Location:	1750 Broadway
Assessor's Parcel Numbers:	008 062301300
Proposal:	To construct a 37-story high-rise consisting of 307 residential units with 5,000 square foot of ground-floor retail space including a five-level parking garage above grade to be accessed from 19 th Street.
Applicant:	Rubicon Point Partners / Chris Relf
Phone Number:	(415) 500-6410
Owner:	1750 Broadway LLC
Case File Number:	ZP170064
Planning Permits Required:	Major Conditional Use Permit for buildings over 200,000 square feet in the CBD-P and CBD-C Zone; and Regular Design Review for new construction.
General Plan:	Central Business District
Zoning:	CBD-P / Central Business District Pedestrian; and CBD-C / Central Business District Commercial
Environmental Determination:	Environmental analysis under review
Property Historic Status:	Non-Historic Property
Service Delivery District:	Uptown
City Council District:	3
Date Filed:	07/19/17 / Revised Design Plans, Dated 02/09/18

Case File: ZPI70064
Applicant: Chris Relf
Address: 1750 Broadway
Zone: CBD-P, CBD-C
Height Area: Height Area 7, No Limit

Re: 1750 Broadway (Case File Number: ZP170064) – Response to Comments from January 31, 2018,
Design Review Committee Meet

PODIUM FACADE - D.R.C. Revision Comments (01/31/2018)

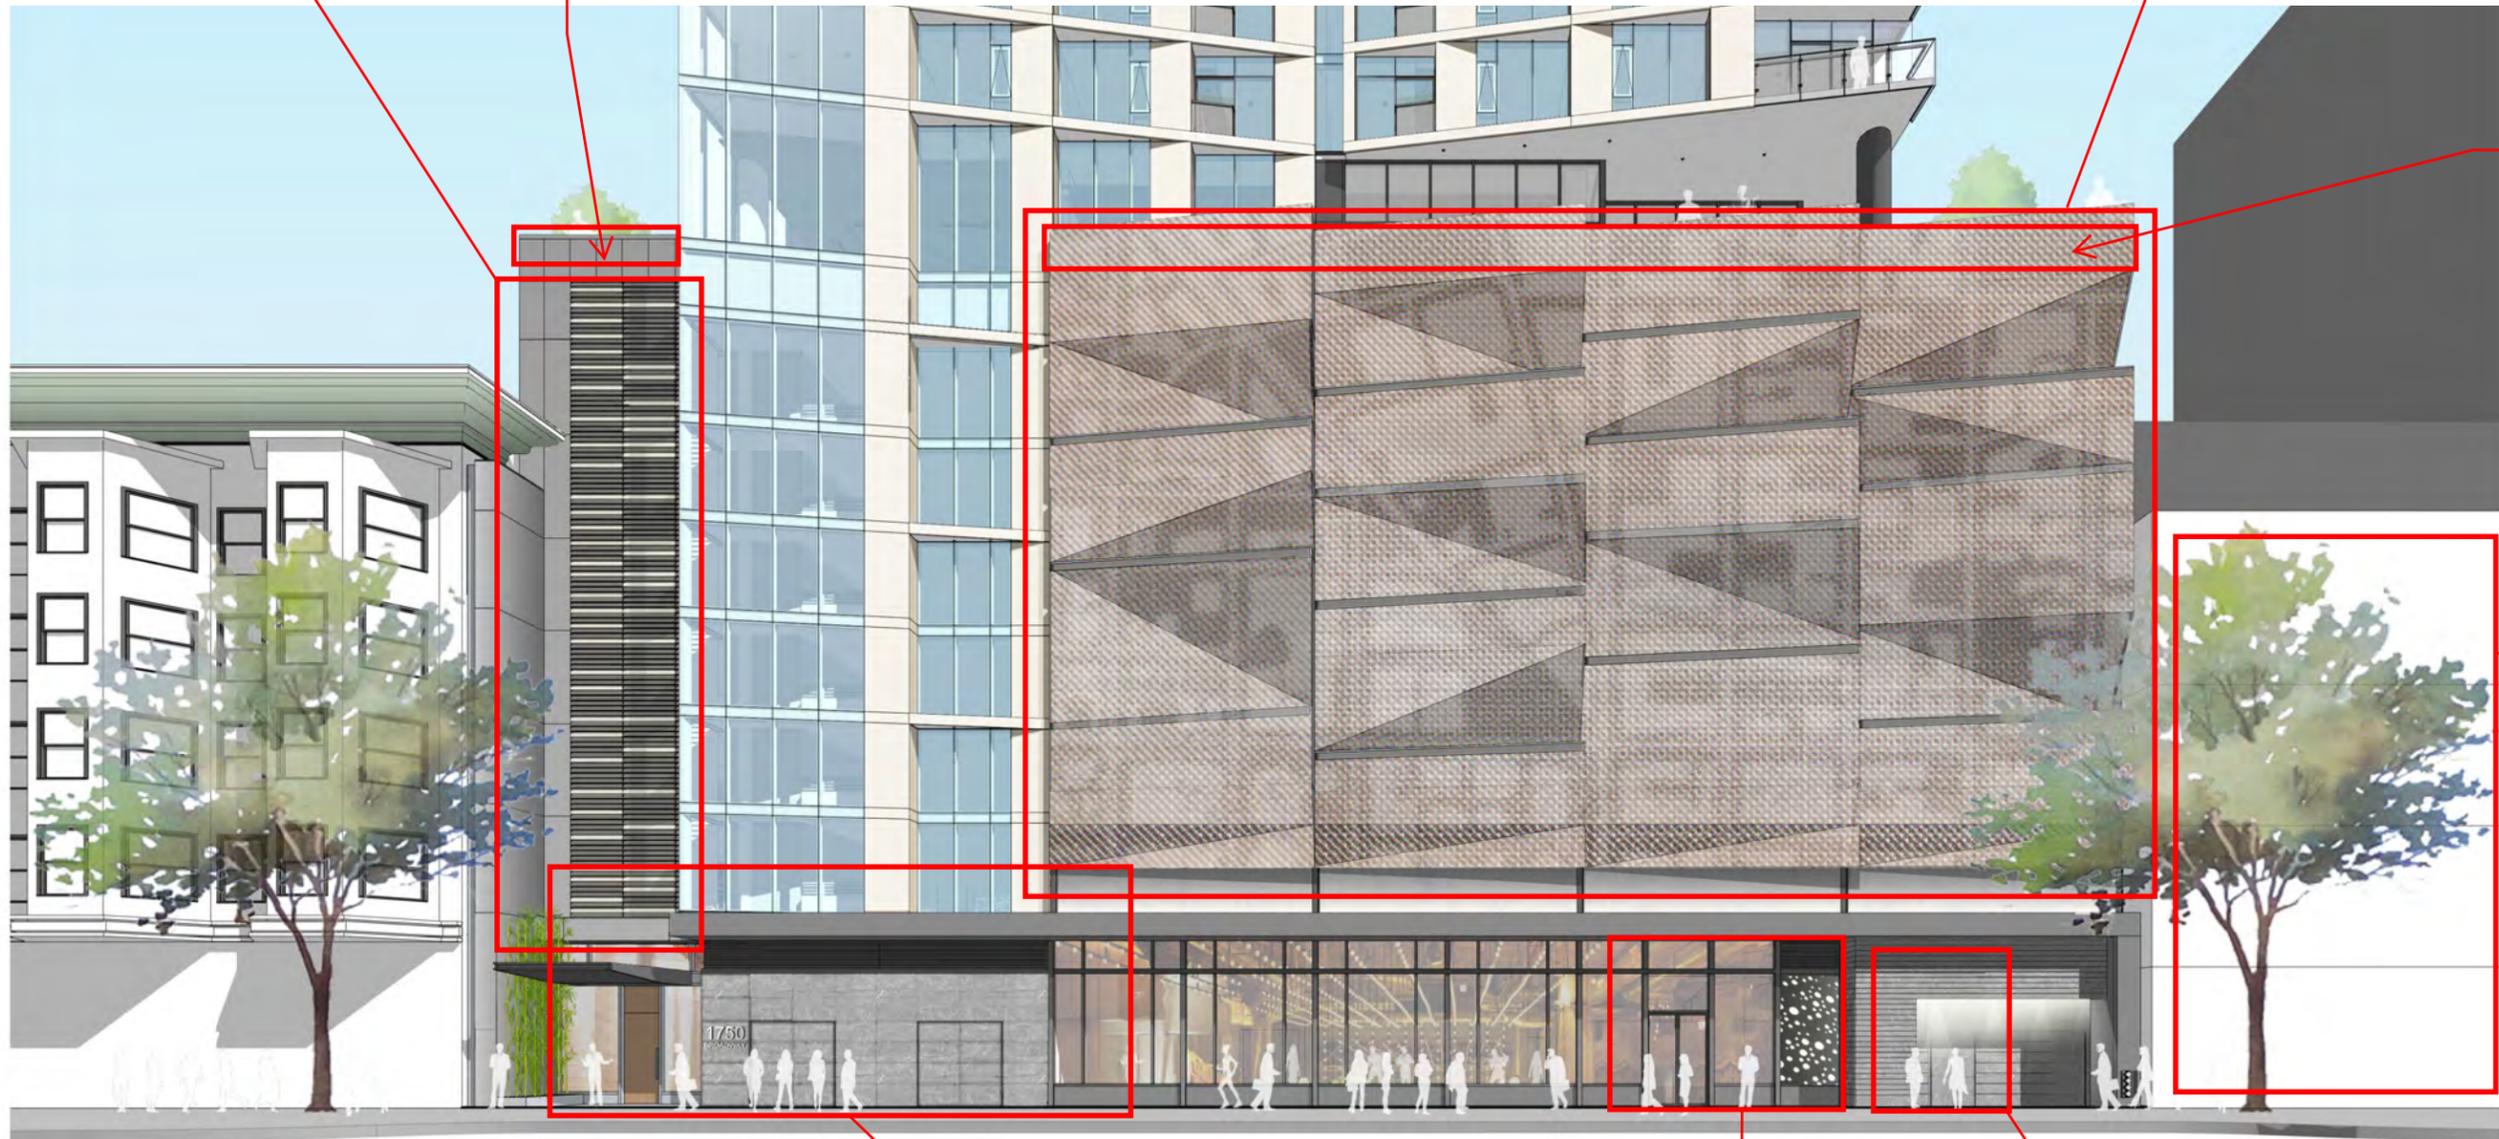
REVISE ELEMENT TO BE MORE COMPATIBLE WITH TOWER

INCREASE TRANSPARENCY OF RAILING AT LEVEL 8

REDUCE VISIBLE IMPACT OF SCREEN, THROUGH SIZE AND DESIGN THAT IS MORE COMPATIBLE TO BUILDING

INCREASE TRANSPARENCY OF RAILING AT LEVEL 8

SHOW FACADE DETAIL OF ADJACENT BUILDING

SIMPLIFY MATERIAL SELECTIONS

REVISE INCREASE GLAZING

CLEARLY MARK BART ELEVATOR

PODIUM FACADE - REVISED DESIGN - OPTION 1B

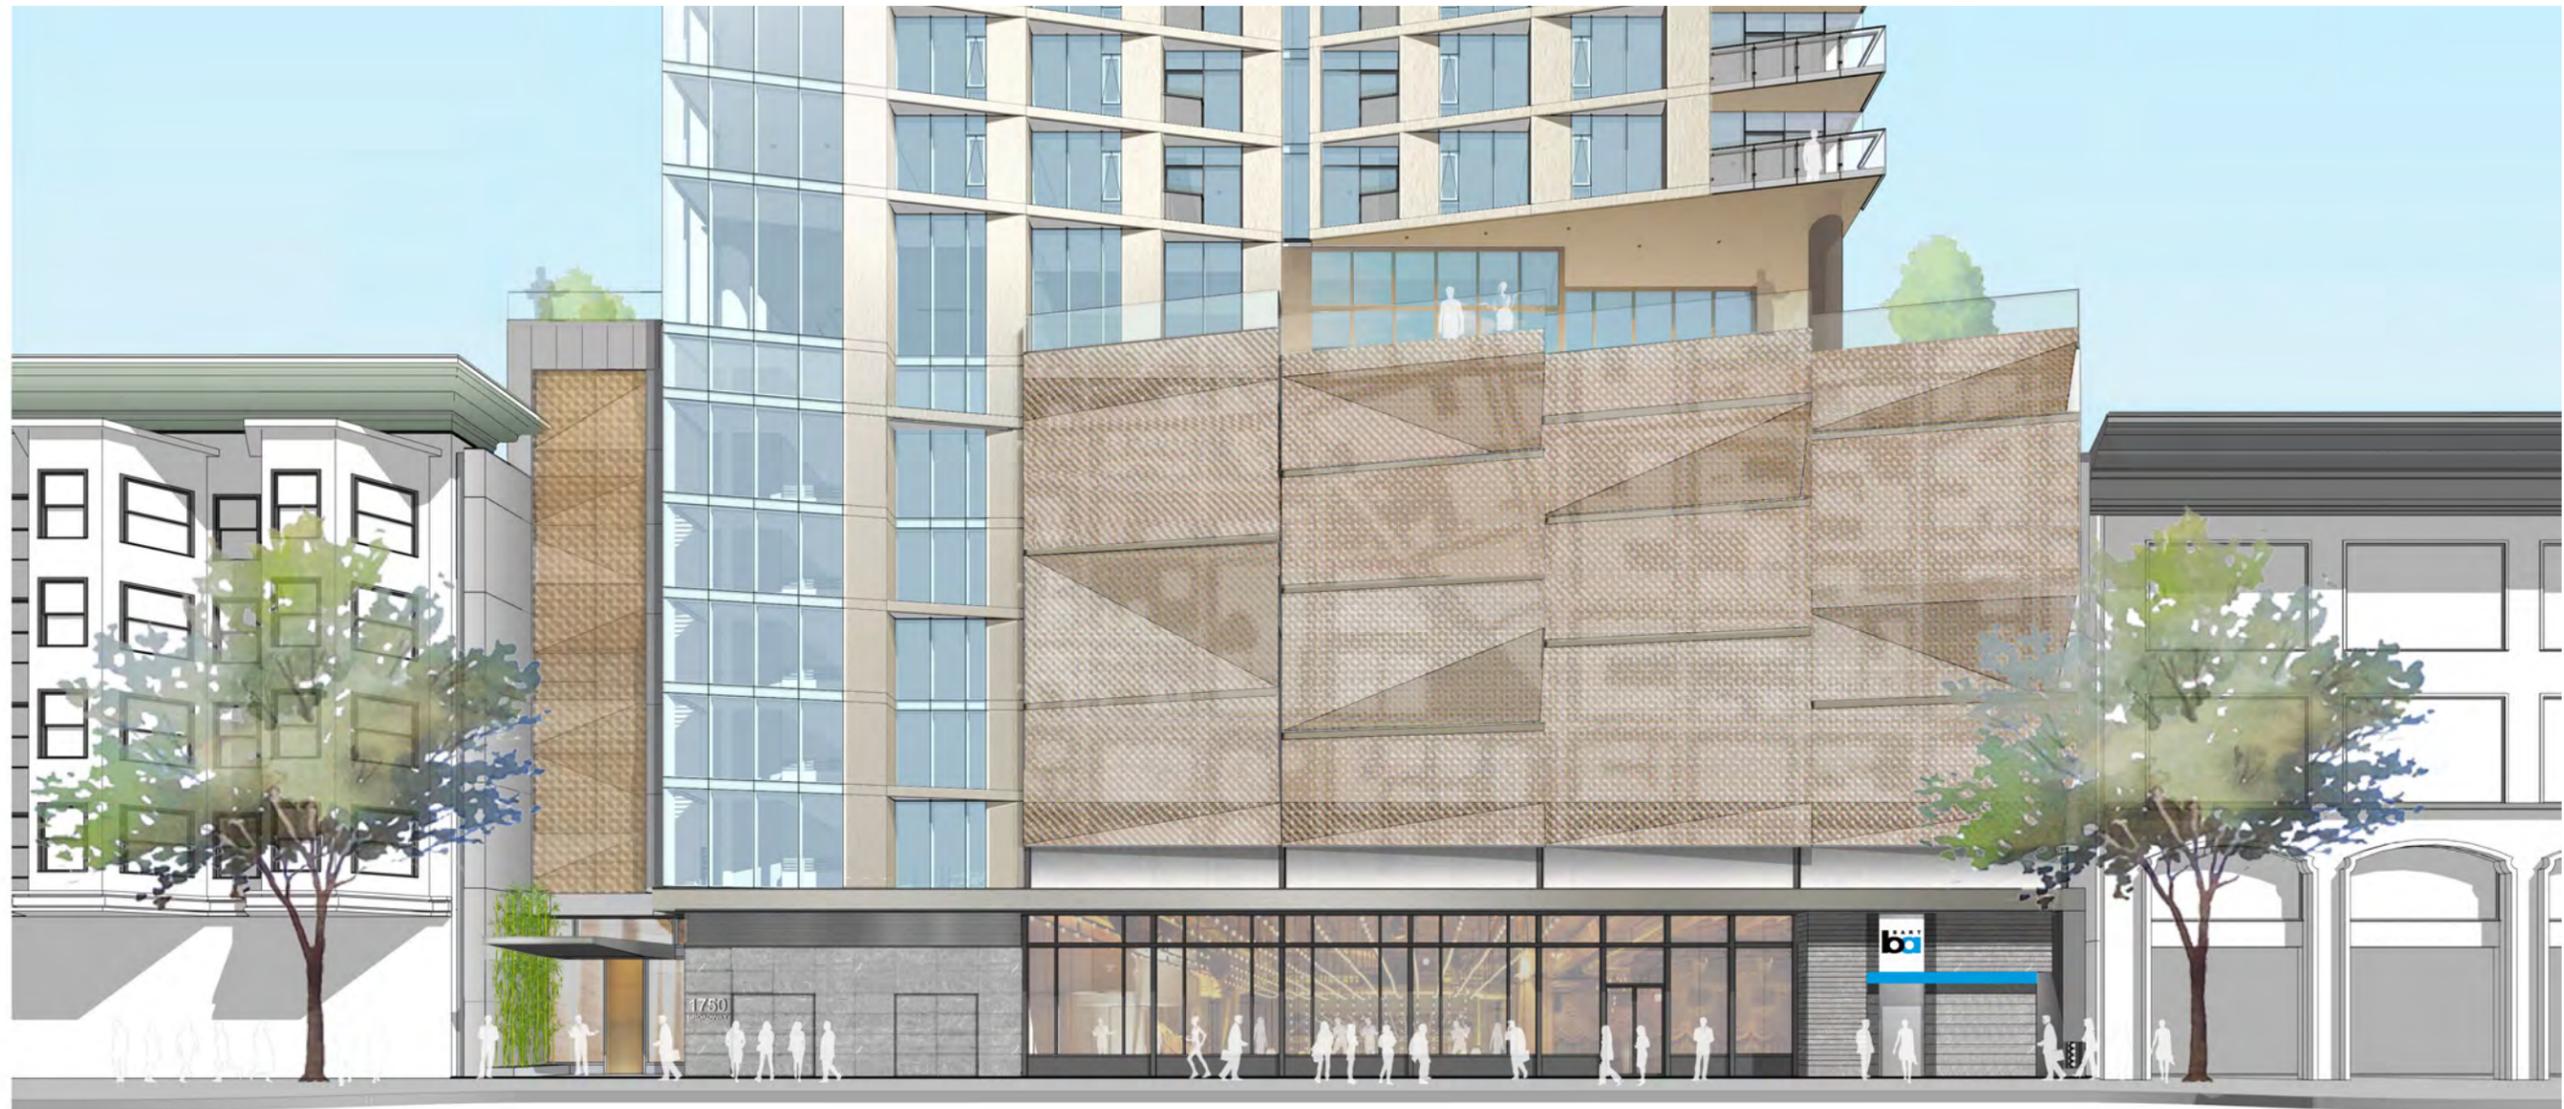
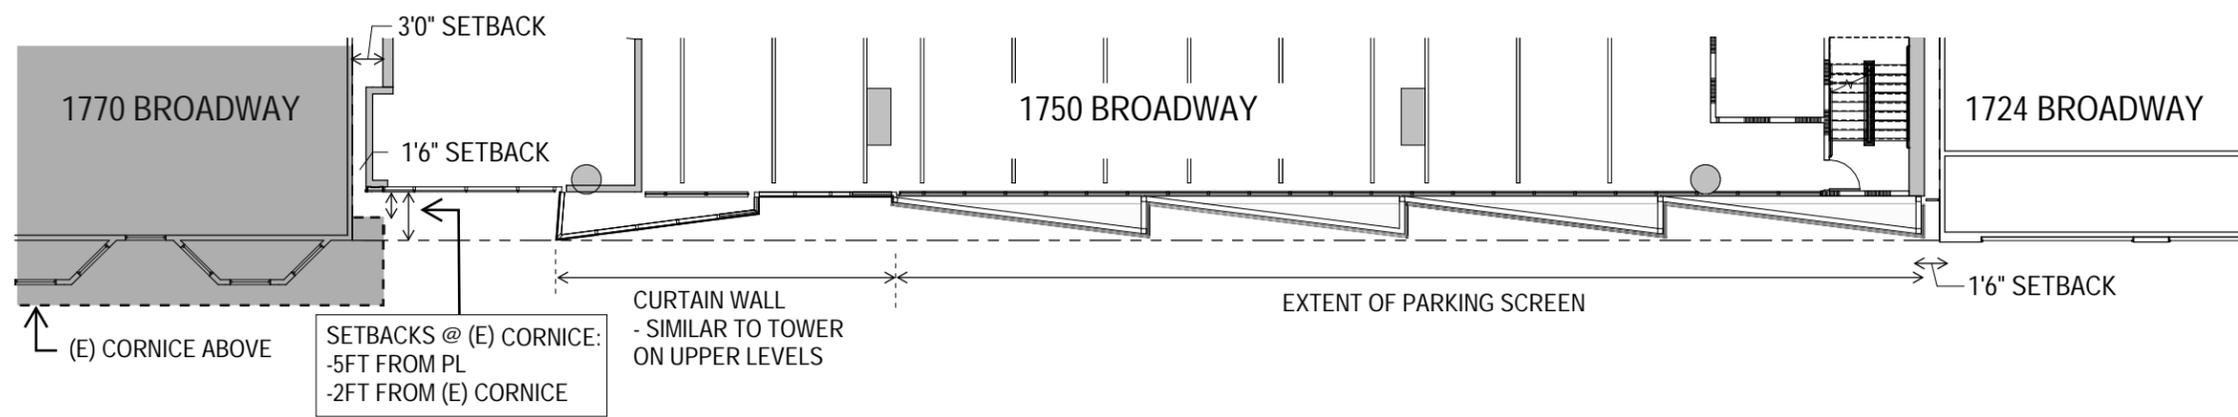
1. Scale the garage façade to create transition and consistency with the building and street-
The revised plans show five design options illustrating the building façade along Broadway. The applicant's preferred design is Option 1B on page 28. This option shows the height of the garage was lowered from six to five levels. Also, the top portion of the garage screen was replaced with a glass railing for the terrace on level 7. The project includes white opaque clerestory windows above the retail space. Staff believes that these changes provide relief from the garage screen, thus improving the transition between the podium and the ground-floor and provides a better design consistency.

APPLICANT PROPOSES 3 OPTIONS;
APPLICANT RECOMMENDS OPTION 1C

Attached to this response are four (4) options regarding the screen massing and garage louvers. The four (4) options reflect a refinement in design and respond to the comments received. The team's preferred option is option 1B as shown on page 29.

POTENTIAL TROMPE L'OEIL MURAL TO VISUALLY COMPLETE THE COURTYARD
PODIUM WALL TO BE SET BACK 3FT FROM PROPERTY LINE FOR AIR AND LIGHT

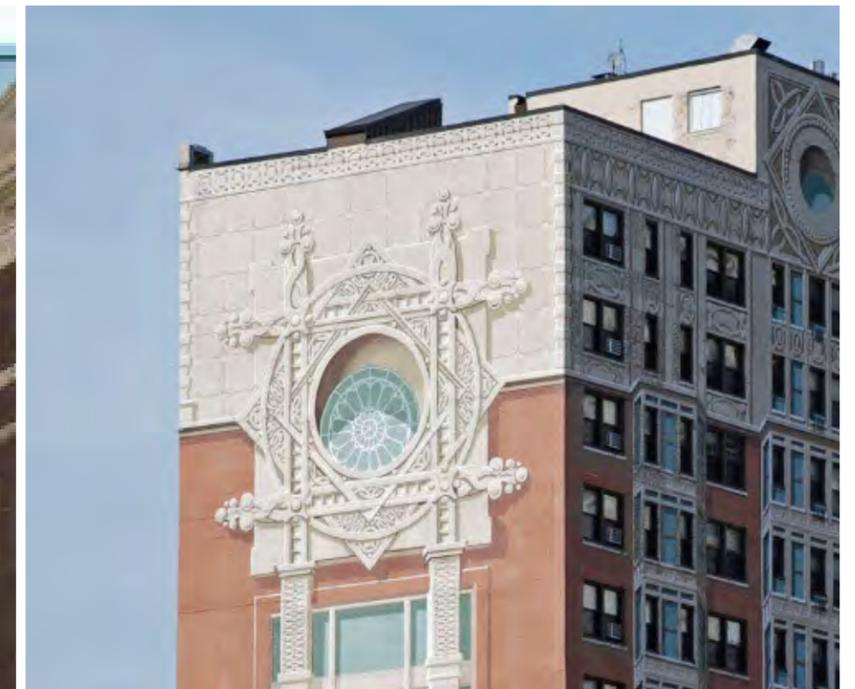
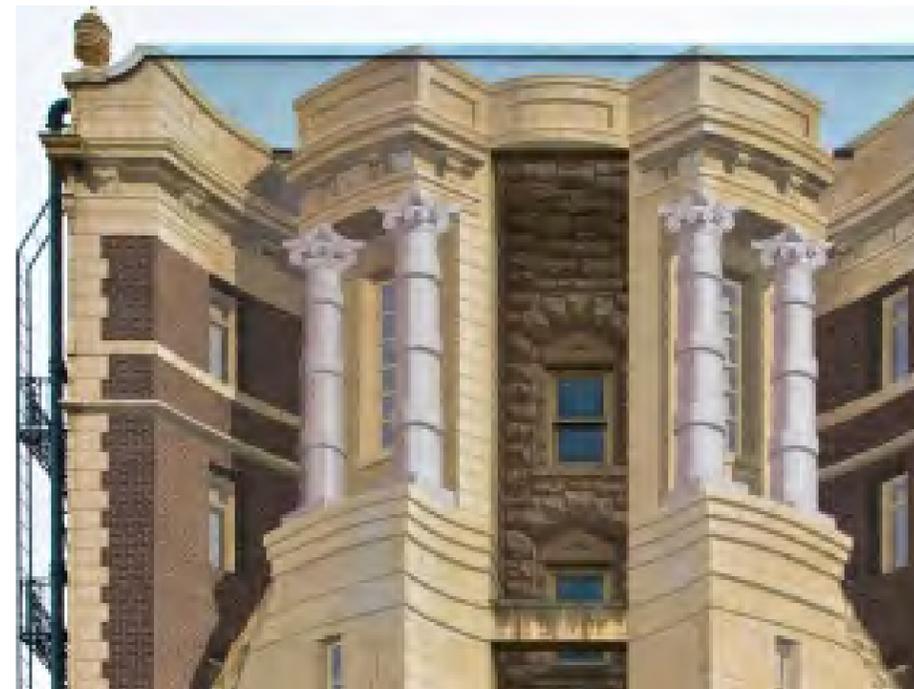
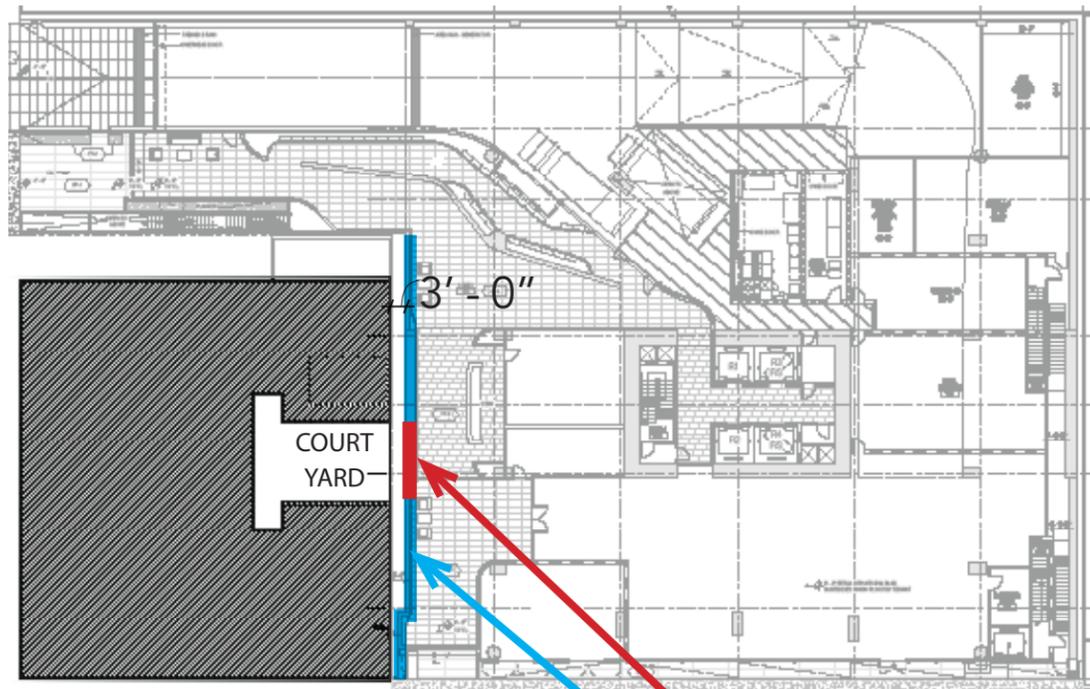
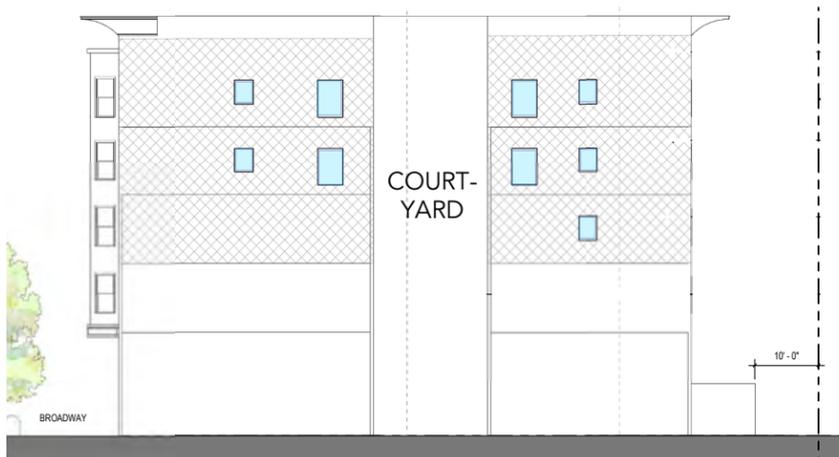
- *The north, south and east garage walls need further massing relief as these are close to residential unit windows and section of blank garage walls would be seen from 19th Street.*

To address concerns regarding the blank garage walls, the project is proposed to commission a mural to be located along these frontages to provide interest and relief. In addition, the building has been setback three (3) feet from the property line to allow additional light and air at property line windows. Images of the proposed mural are shown on page 34 of attached exhibit, but we will work with our neighbors to create a design and feel that addresses their concerns and creates the visual relief requested. Page 40 also shows the elevation view from 19th Street with the garage louvers and garage wall architectural treatment to depict the future streetscape from this corridor.
